From: Morne Theron <Morne.Theron@capetown.gov.za>
Sent: Tuesday, 06 June 2017 12:10 PM
To: Annei Kloppers
Cc: Barry Wood; Pierre Maritz; Peter Flower; Deon Jeannes; Bulk Water Info; Kevin Balfour; Adél Groenewald
Subject: Farm Duynfontein No 1552, Melkbosstrand: Hardened water reservoir at Koeberg Nuclear Power Station: Draft BAR _ Eskom request to fill the proposed new Hardened water reservoir
Attachments: CFM 1552 KNPS_Hardened Water Tanks_DBAR_ City comment.pdf; Figure 1_CTN-R51.pdf; NSC-007-17_Permission to store water_Koeberg.pdf

CAPE FARM 1552 DUYNEFONTEIN: KOEBERG NUCLEAR POWER STATION PROPOSED HARDENED WATER RESERVOIR AND ASSOCIATED PIPING – DRAFT BASIC ASSESSMENT REPORT
[City Reference: B21/1/2/2/13S]
[DEA Reference: 14/12/16/3/3/1/1759]

FIGURE 1

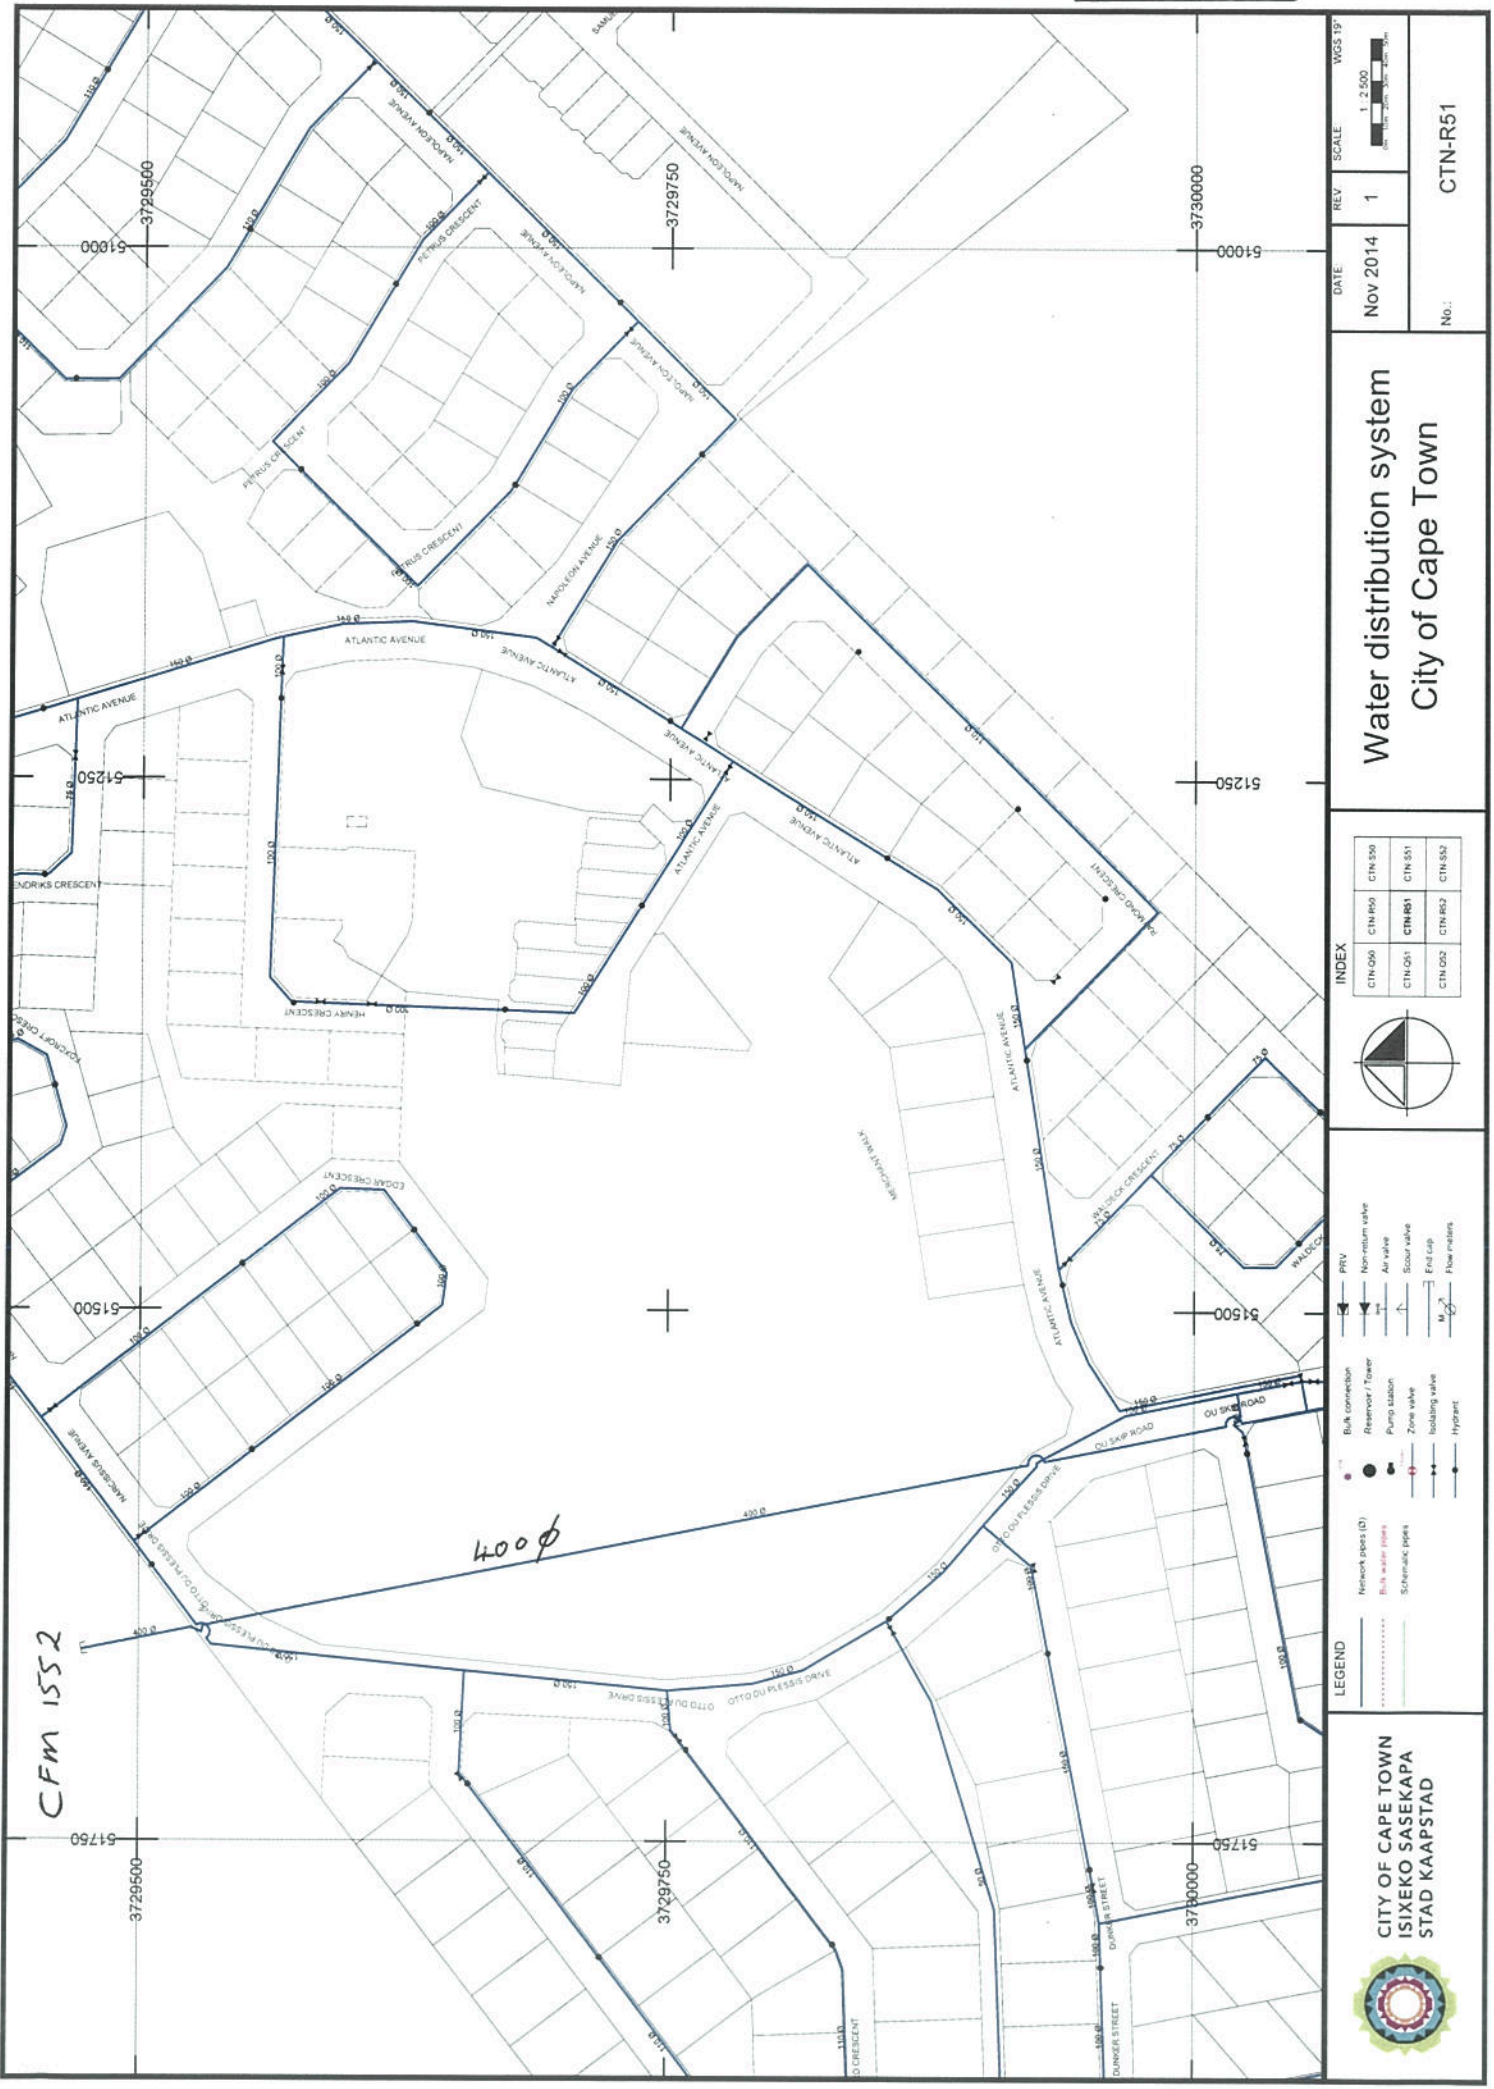
There is water supply to the southern boundary of the Cape Farm 1552 by means of the existing 400mm water supply located off Otto du Plessis Street (refer to the Water Distribution system plan, Drawing No: CTN-R51, attached Figure 1).

The peak pressure in the 400mm water main is about 74m. The 400mm supply is capable of delivering 144 l/s maximum. In practice this means it will take about 18,5 hrs to fill the reservoir.

[Note: There is also a 500mm water main along the Westcoast Road however the 500mm water main is dedicated to the far north (i.e. Atlantis , Pella and Mamre) and not suitable to draw from]
